City of Plymouth Planning Commission

Regular Meeting Agenda

SP 24-02: 413 N. Main, Special land use and site plan review for expansion of outdoor dining area

**Special Land Use and
Site Plan Review
For
Plymouth, Michigan**

SHEET NUMBER
ST1.1

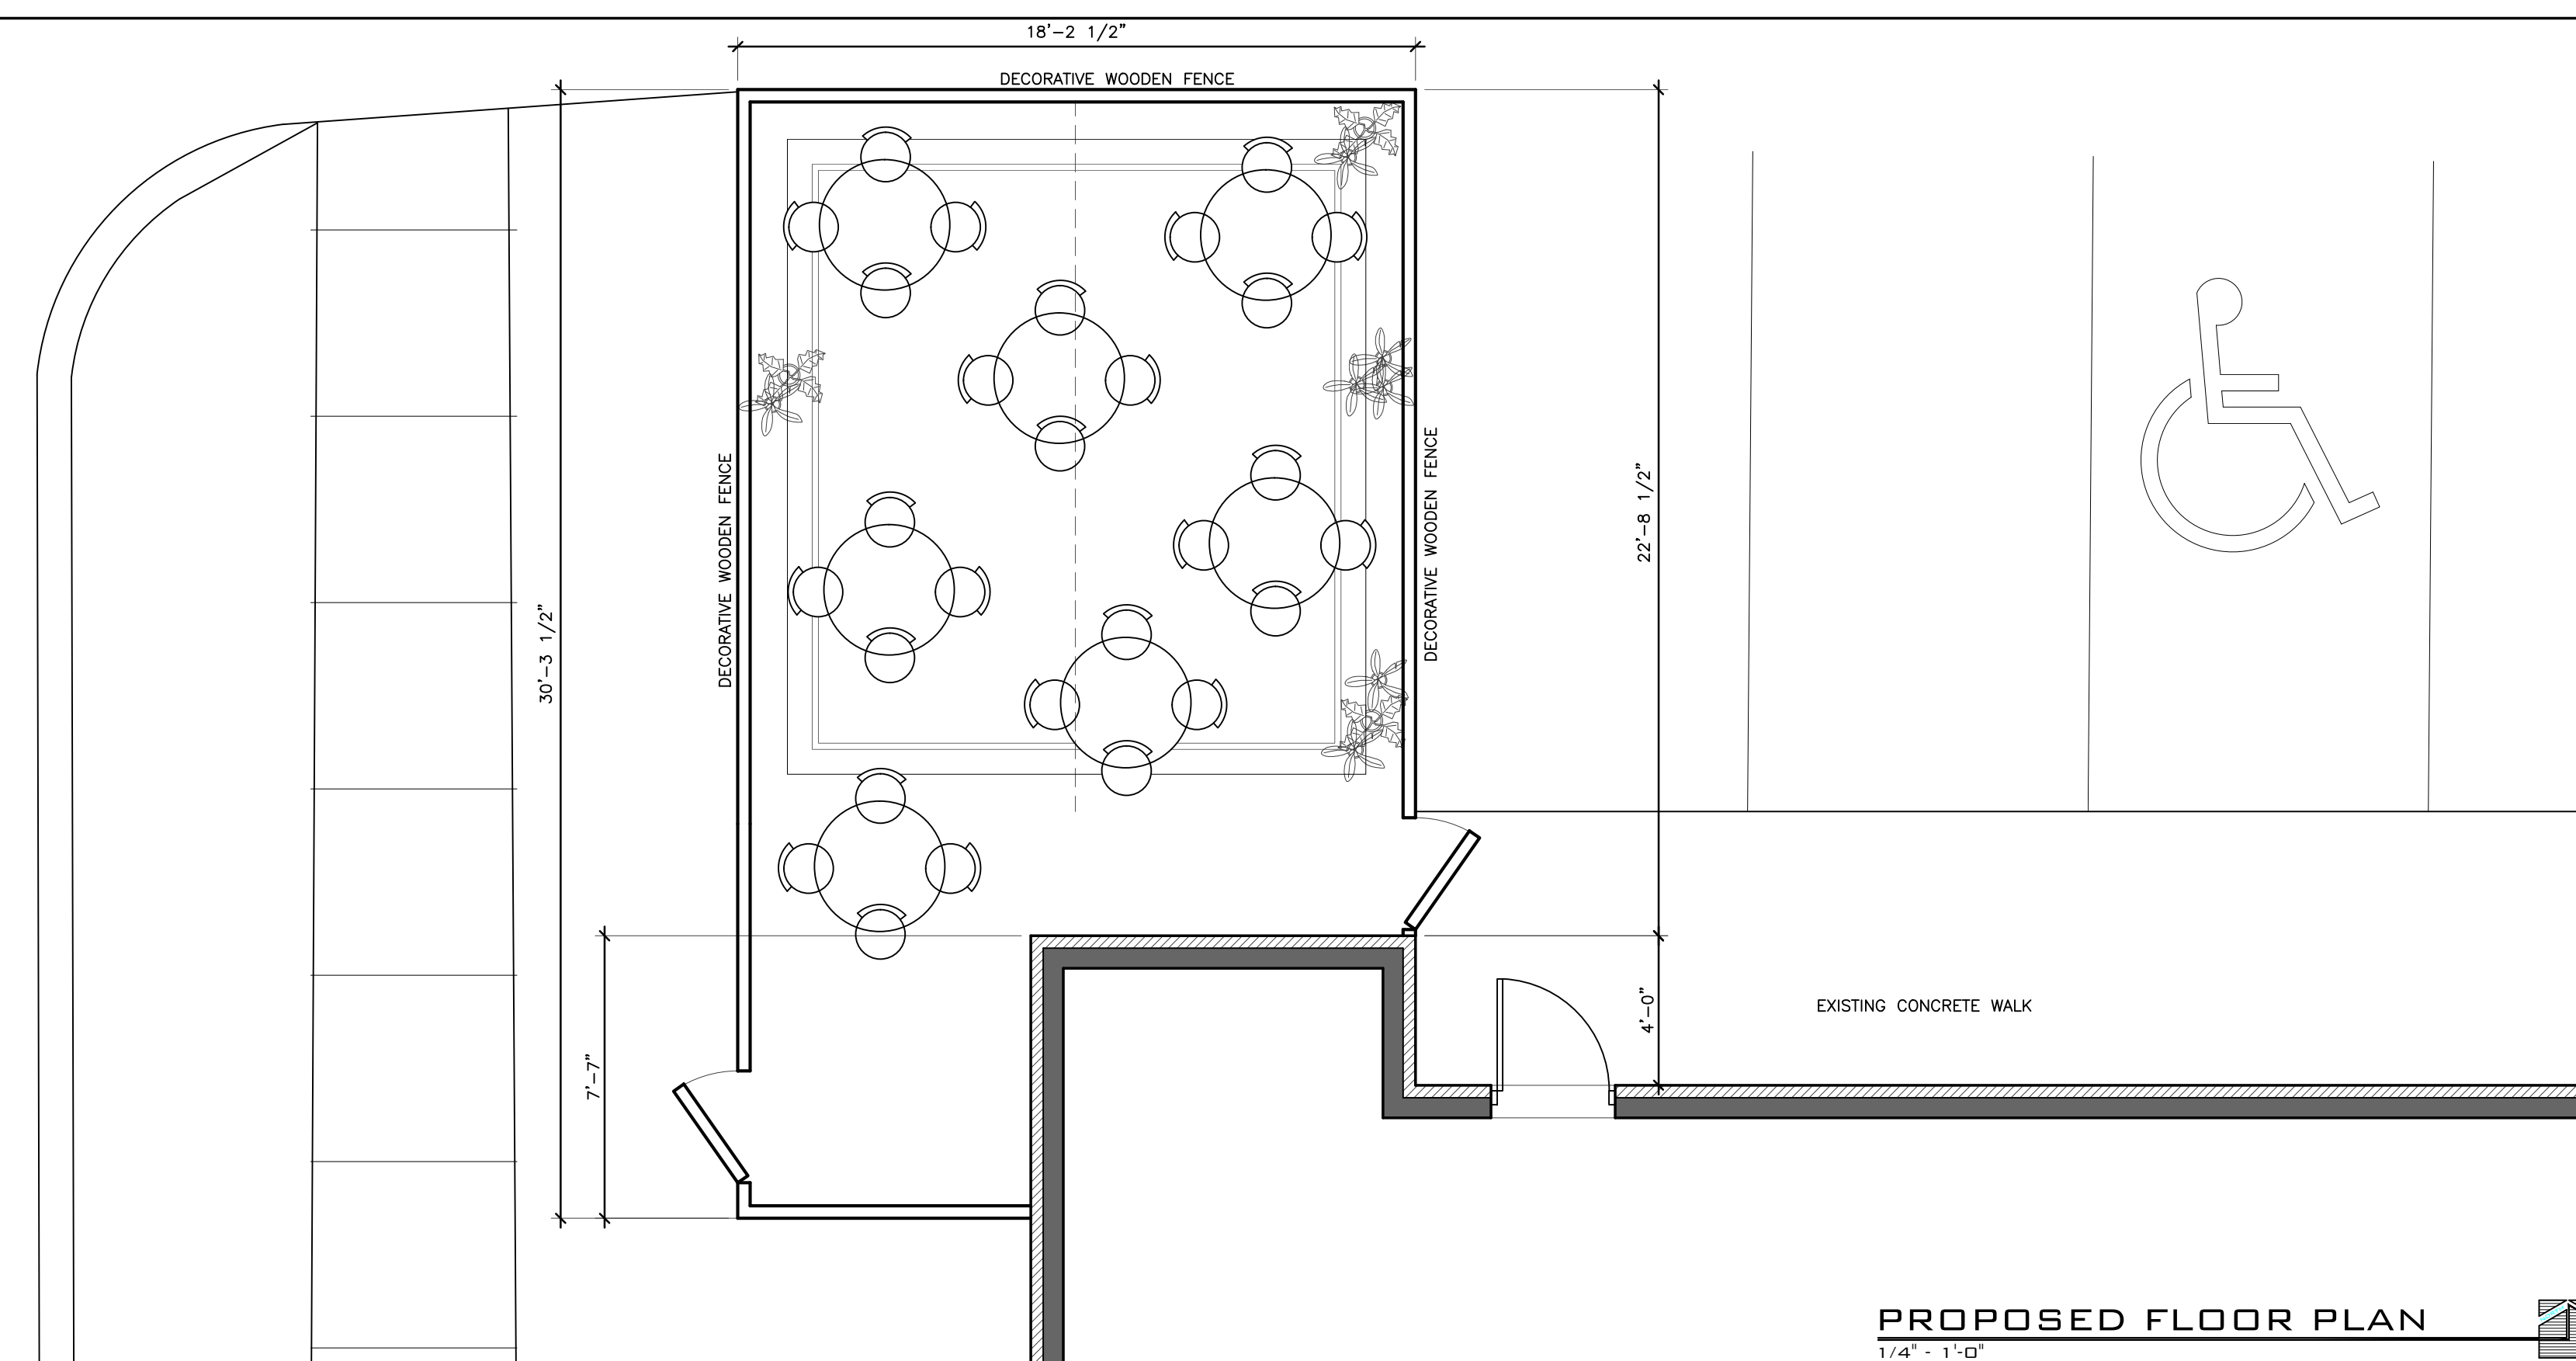
The outdoor dining area is proposed to be located in the two most westerly parking spaces on the north side of the building. The patio will be in the Starkweather right-of-way by one (1) foot. The proposed dining use should not be placed in the right-of-way. Therefore, the plans should be revised to remove the patio from the right-of-way. We recommend that this be a condition of approval, if granted.

No permanent structures are proposed. Sheet ST1.1 shows photographs of when an outdoor dining area was installed up next to the sidewalk in previous years, with a black fence. In our previous review, we asked if the same fence/umbrellas/chairs shown in the photos be used if the outdoor dining area is approved. A note next to the photos states: "Pictures shown are of a previous installation and are shown to illustration construction type and quality." The plans also show that the outdoor dining area will accommodate 7 tables/28 patrons.

Per Section 78-247, the submission shall show specific site information. A site layout, including the building to the north, is provided on Sheet ST1.1. All required information has been provided.

The plans show 3,839 gross s.f. of floor area for the existing building, and 473 s.f. for the outdoor dining area. We have the following comments/questions:

- c. The width of the barrier-free aisle is one (1) foot too narrow. The aisle needs to be a minimum of 8-foot wide, and the plans should be revised to show this change. This can be accomplished by narrowing the barrier-free space to 8-feet. (When only one barrier-free space is required in a parking lot, it must meet the “van-accessible” dimensions, which are 8-feet wide for the barrier-free space, with an 8-foot wide aisle.)

- 1) Planning Commission to consider Director of Public Safety report.
- 2) Revise plans to remove the patio from the Starkweather right-of-way.
- 3) Planning Commission to discuss the addition of landscape planters along the west side of the dining enclosure fence.
- 4) Will the current hours of operation for the restaurant also apply to the outdoor dining area?
- 5) Will the outdoor area be used only for patrons eating a meal, or will patrons only using the bar also be able to sit outside?
- 6) Is the applicant proposing any outdoor speakers or music?
- 7) How will the outdoor area be managed to minimize disturbance to nearby residents?

- 1) Condition approval, if granted, on the applicant confirming/obtaining City Commission approval for the 4-season structure and parking space location in the Starkweather right-of-way.
- 2) Condition approval on the plans being revised to locate the new outdoor patio out of the Starkweather right-of-way, and out of the adjacent parking space.
